Docket Nos. 50-352
50-353

Subject: Limerick Generating Station (LGS)-Units 1&2
Open Items from NRC Draft Safety Evaluation
Report (DSER) - Structural Engineering
Branch (SEB)

ENCLOSURE 1
Response to LGS DSER-SEB Open Item Numbers 1, 4, 8, and 9

CONTAINMENT MODEL - REDISTRIBUTION OF HORIZONTAL

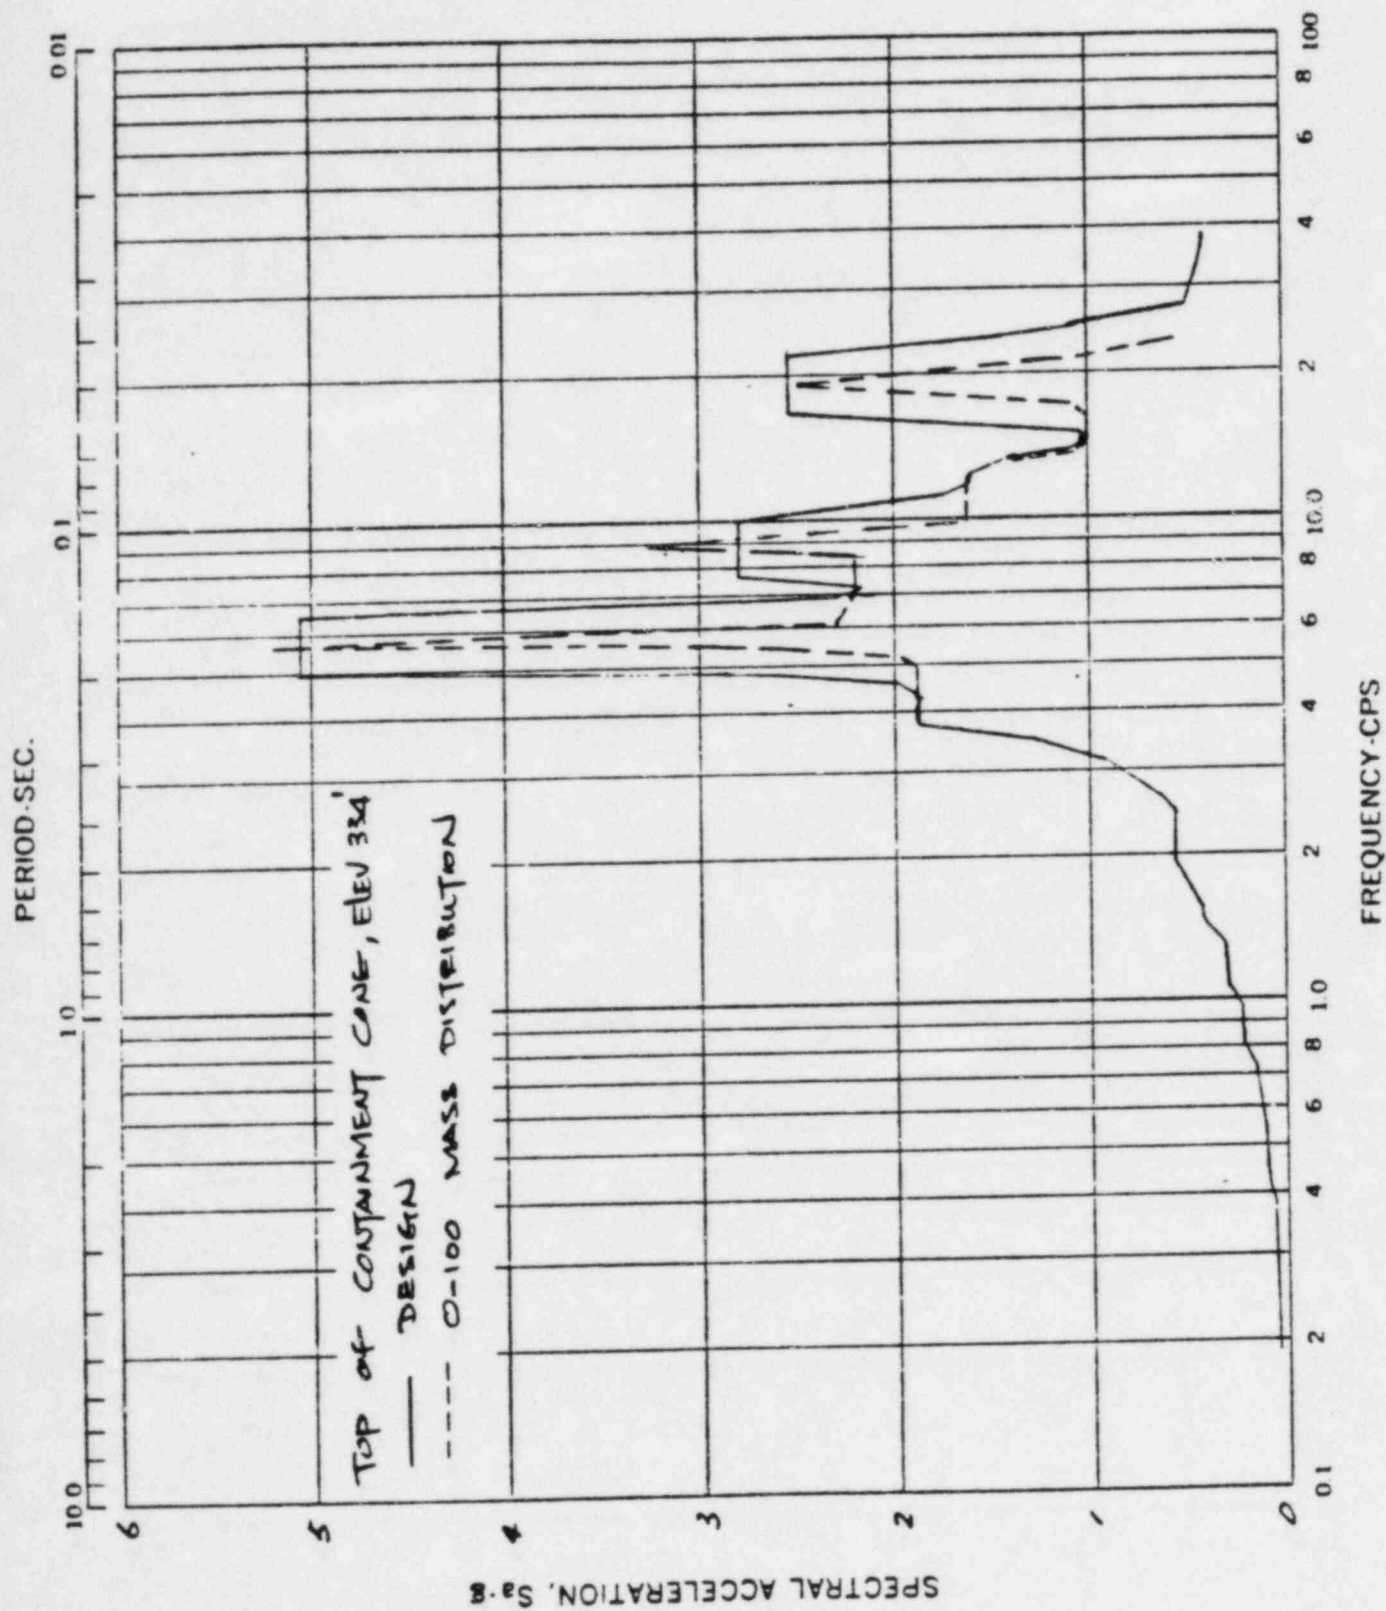
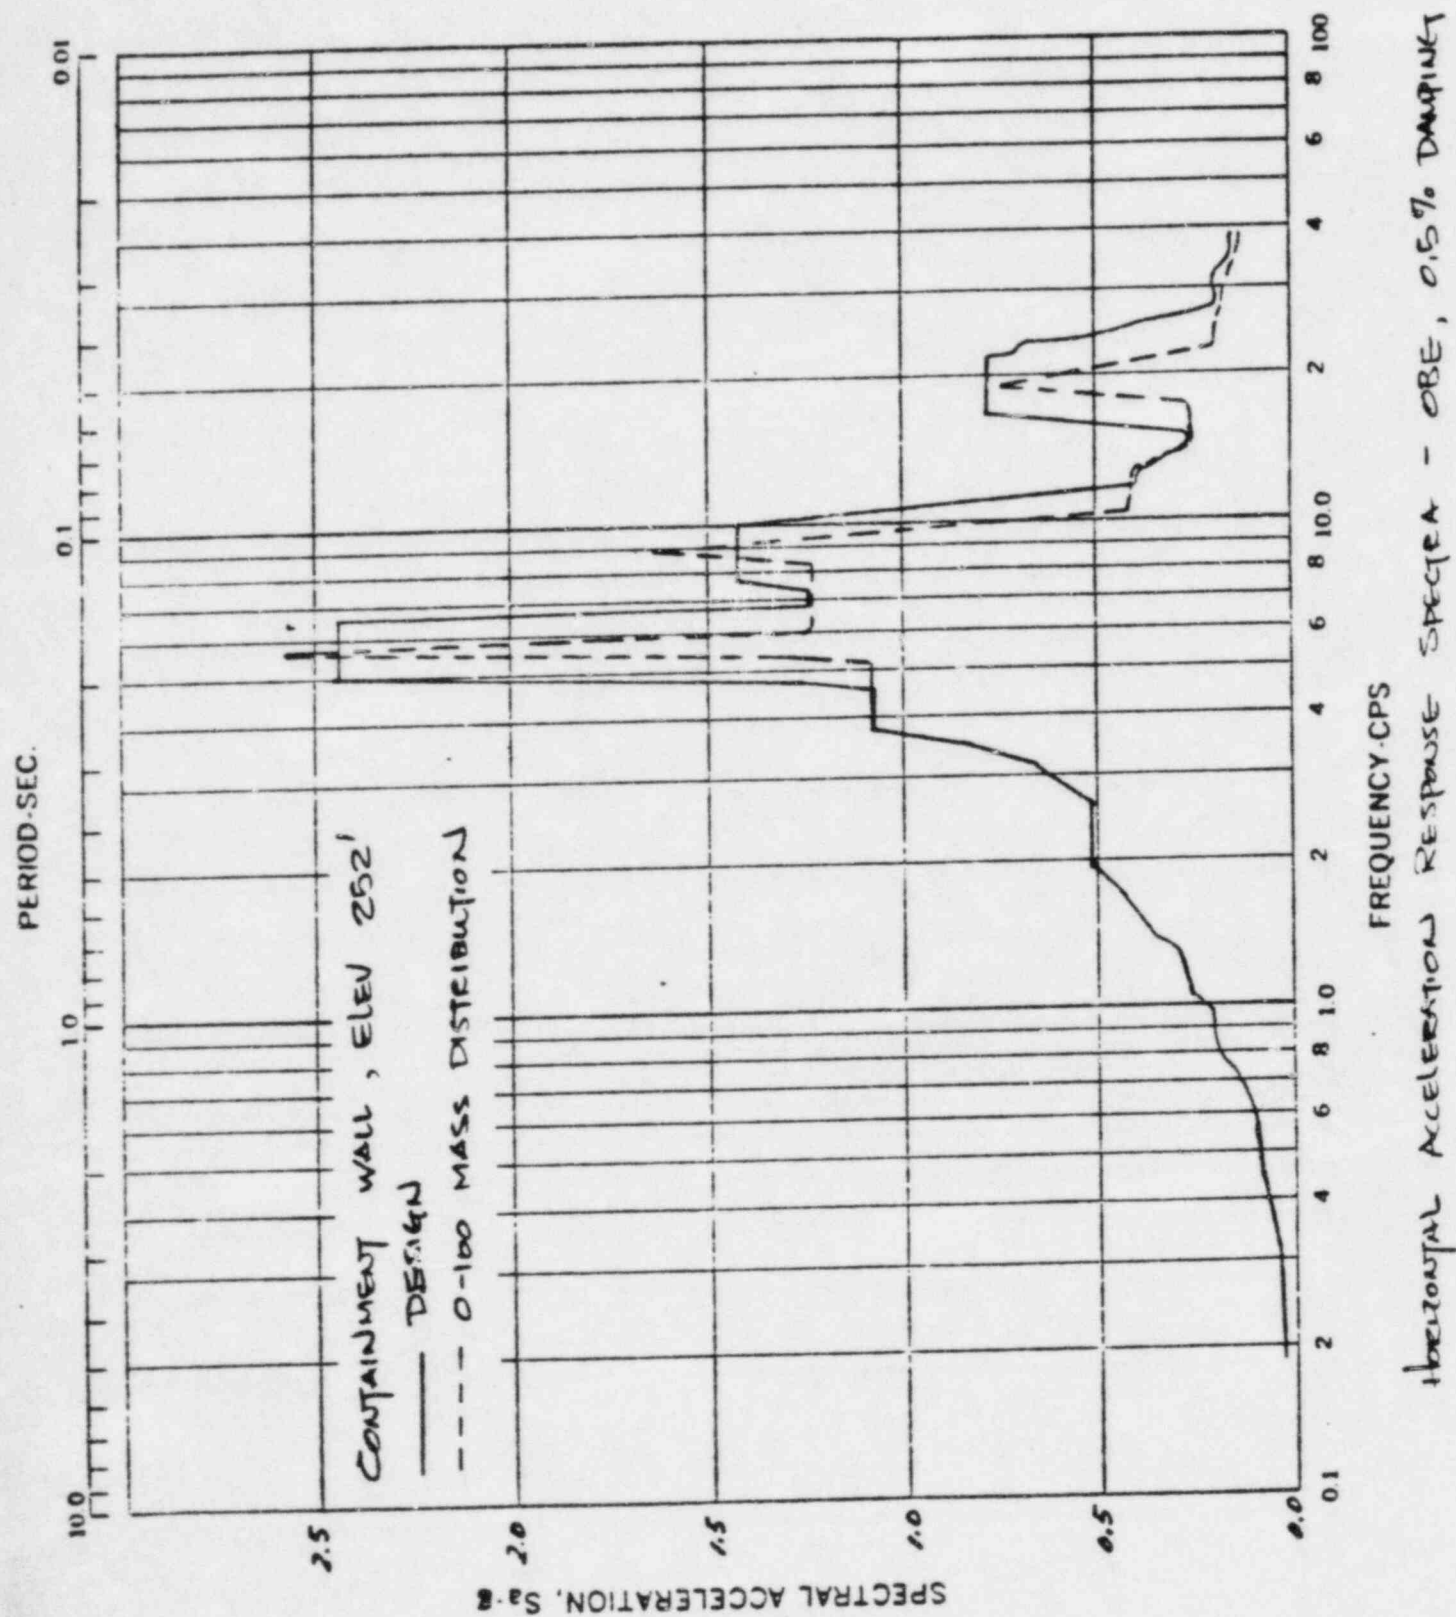
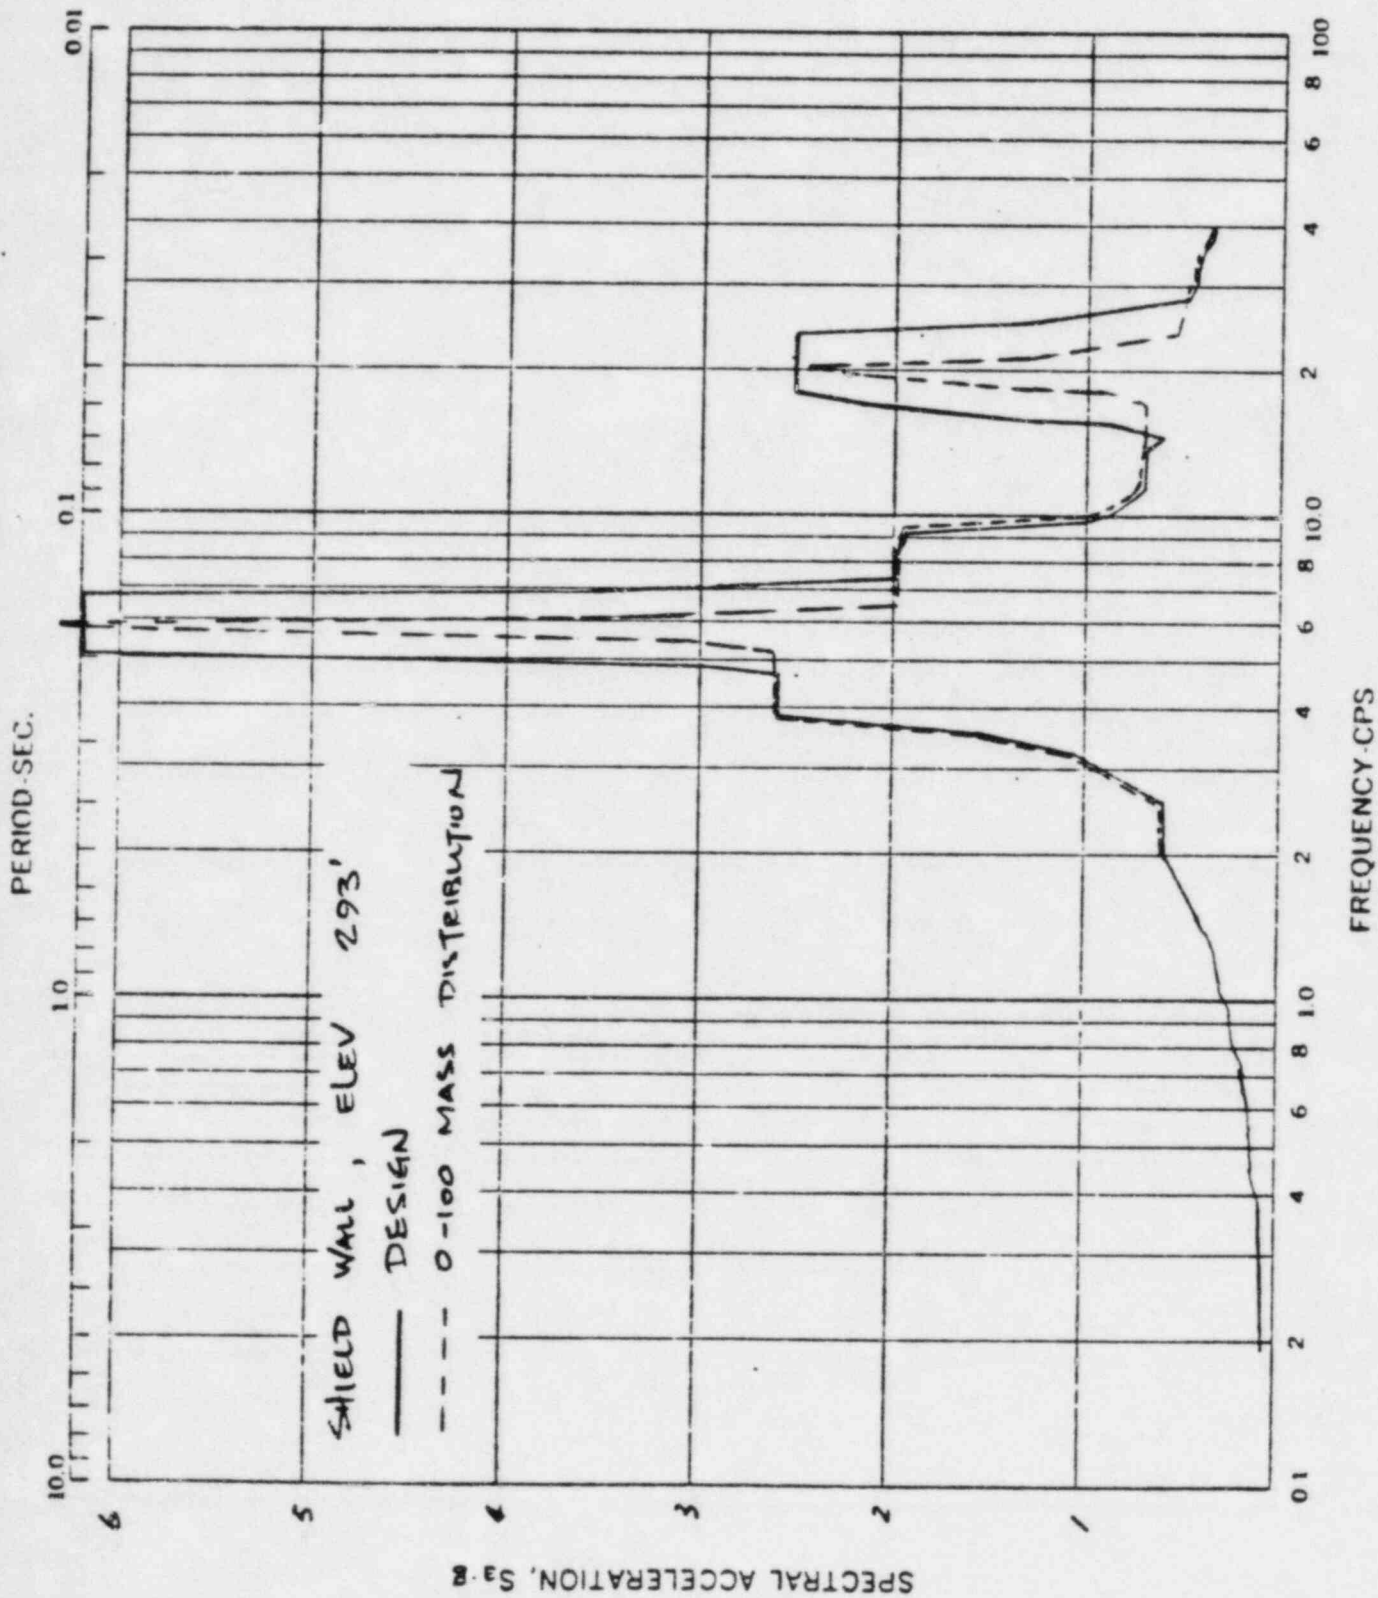
In addition to the problems with the rock parameters mentioned in (3) above, a structural design audit performed by the staff revealed problems with the containment dynamic model. These problems consist of errors in calculating the containment diaphragm slab spring stiffness and mass distribution of the containment building floors. The staff considers these problems to be open issues.

All platforms spanning between the containment wall and the RPV pedestal wall in the drywell are supported in the horizontal direction only at one end and are free to slide at the other end. They are supported at both ends in the vertical direction. Current horizontal and vertical seismic models of the containment structure assumed a platform mass distribution of 80% to the containment wall and 20% to the pedestal wall. A study has been performed using the uncracked containment models to determine the effects of different distribution of this platform mass.

The horizontal study model considers 100% of the platform masses lumped to the restrained ends and zero mass to the unrestrained ends. The vertical study model redistributes the platform masses to the containment wall stick and to the RPV pedestal stick of the model according to tributary area (approximately 60% to the containment wall and 40% to the pedestal wall).

The study models were analyzed for the OBE event and the results compared to the design values. These comparisons are shown in attachment 2 for the horizontal model and in attachment 3 for the vertical model.

These comparisons show that the distribution of platform masses have negligible effect on the structural response of the containment structure. Therefore, the current seismic analysis of the containment structure is adequate.
